OU1 Design Change and Modification Sheet: Change/Modification # 27

OU1-REMEDIAL ACTION PROPOSED AREAS 2 & 3

LIBBY ASBESTOS PROJECT

RESTORATION PLAN

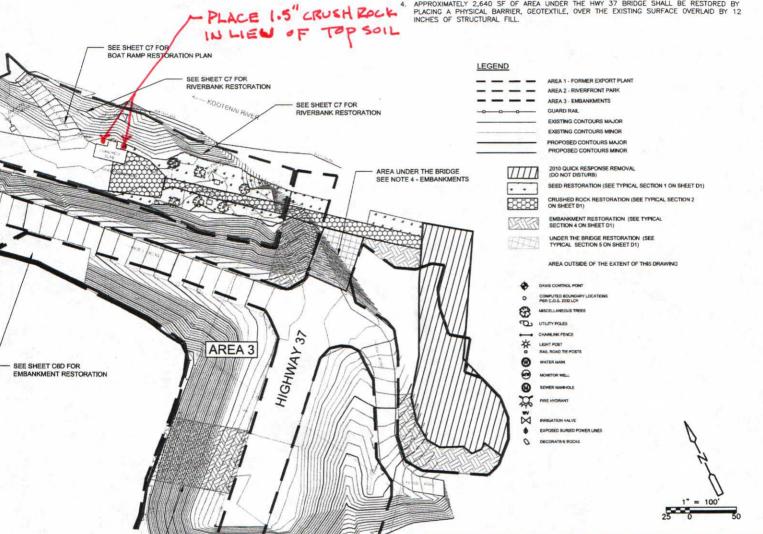
Date Initiated: 5/21/12	Date Exe	cuted: 5/24/12	
Property ID: Operable Unit 1 (Area 2)			
Design Change / Modification Description:			
soil at the rear/northerly side eliminate the development of	ter hydrant pad. Place 1.5" cr e of the concrete pad to facilit f mud resulting from water ru	tate run-off drainage and	
concrete pad.			
Changes marked on Quality	Control Plans? Yes	No	
Signatures: Approved: USACE or EPA:		Date: <u>5-24-1</u> 7	
City of Libby: Jim Hum	nmar	Date: <u>5/24/201</u> 2	
Acknowledged: CQC:		Date: 5/24//3	
TQA: Julia		Date: <u>\$\24\12</u>
